STAFF REPORT

Community Planning and Preservation Commission Certificate of Appropriateness Request

Case No.: 22-90200119
REQUEST: Review of a Certificate of Appropriateness application for a new single-family house and a garage with an ADU at 2101 3rd Ave N, a vacant lot in a local historic district. This application includes a FAR bonus request of .1 FAR.
ADDRESS: 2101 3rd Avenue North
OWNER: TRB DEVELOPMENT ENGLEWOOD LLC
APPLICANT: Jonathan Meyer, Owner
LOCAL LANDMARK: Kenwood Section – Southeast Kenwood Local Historic District (18-90300001)

HISTORIC STAFF REVIEW SET
 OPTION 2

Figure 4: Front and rear elevations of proposed house and garage ADU.

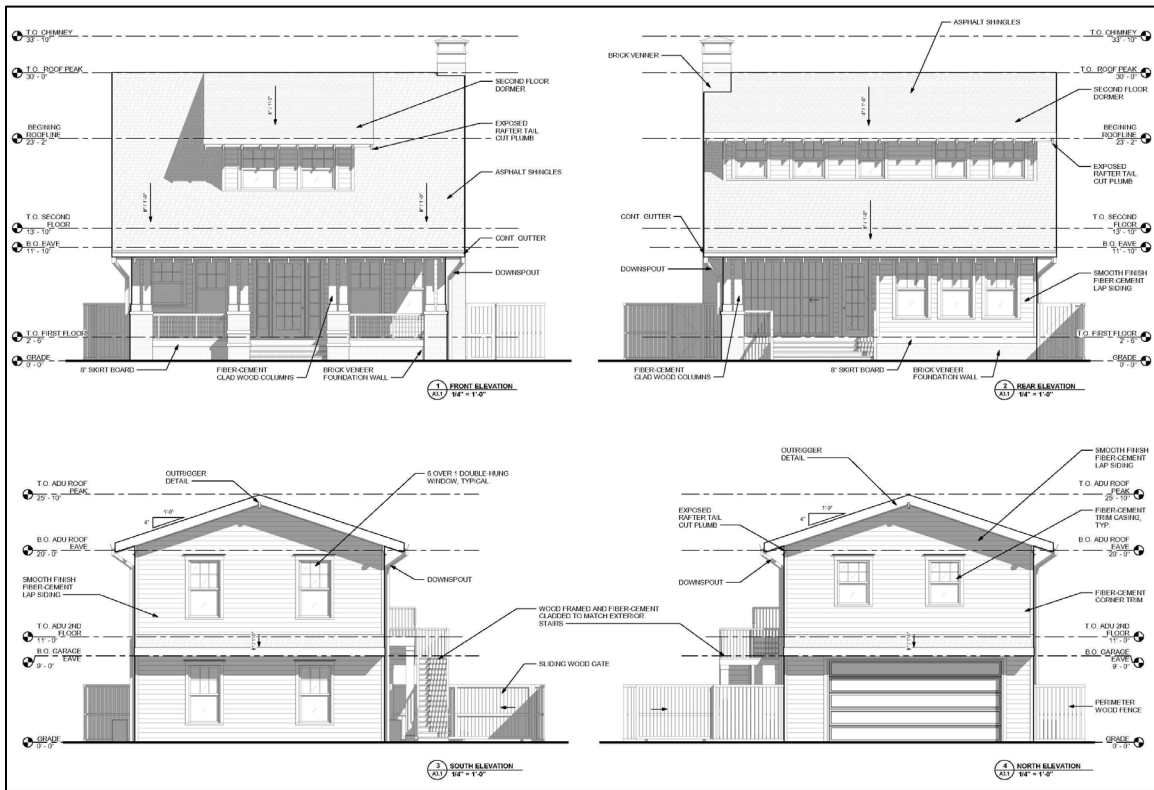
Staff suggests that the following elements of the proposed building be closely considered by the Commission in their review, as features that most closely define its relationship with the historic district:

- Two-story house with detached garage apartment;
- Orientation toward narrow side of parcel;
- Total width of primary residence is 33 feet by total length 44 feet on the first floor (this includes a covered lanai area on the streetside elevation);

- The second-floor length is 33 feet wide by 30 feet long (this does not include a front dormer bumpout);
- Primary structure's total height is proposed to be 30 feet from grade with finished floor elevation at 2 feet, 6 inches above grade;

- The garage apartment building will be 26 feet wide by 25 feet, 4 inches long with a height of 25 feet, 10 inches;
- Fiber cement lap siding on the exterior façade;

- House will utilize an asphalt shingle roof in a side gable form with a front and rear shed roofed dormers;
- Aluminum six-over-one sash windows;
- 15-light, single action front door with no sidelights;

Consistent The new construction is proposed to be 30 feet tall. While most structures in the district are one-story, many two-story structures have a similar height.

Consistent The width and height of the front elevation and the streetside elevations are compatible with the other contributing resources in the district.

Based on a determination of general consistency with Chapter 16, City Code of Ordinances, staff recommends that the Community Planning and Preservation Commission **approve** the Certificate of Appropriateness request for a new single-family home with detached garage at 2101 3rd Ave. N with the following conditions:

1. Windows and doors will be installed to be setback within the wall plane and feature a reveal of at least two inches, and feature contoured, exterior three-dimensional muntins to reference traditional muntin design.
2. A historic preservation final inspection is required.
3. All other necessary permits shall be obtained. Any additional work shall be presented to staff for determination of the necessity of additional COA approval.
4. Any other design changes not included as part of this COA review and approval shall require the approval of the CPPC, with the exception of minor changes as deemed appropriate by staff.
5. This approval will be valid for 24 months from the date of this hearing, with an expiration date of January 10, 2025.

Figure 5: Proposed side elevations of the project.

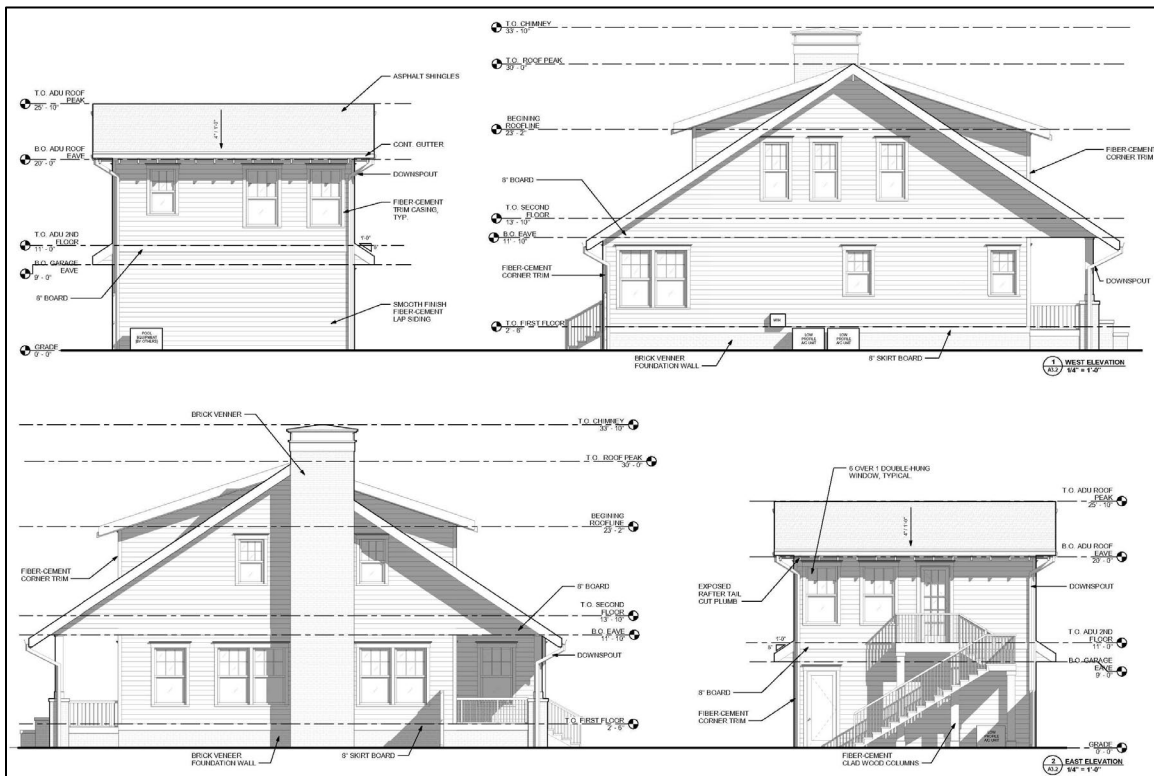
Consistent The new design incorporates a pattern of windows on the front and streetside façade, following traditional patterns. The proposal also includes a chimney on the streetside that helps to break up the massing and create articulation.

Consistent Side gables roof forms are a traditional element of Craftsman design, which is the predominant architectural style in the district.

Consistent The new proposal incorporates more traditional massing of the primary structure, incorporates a window rhythm on each façade, and utilizes a traditional Craftsman form of an integrated front porch that is compatible with the district.
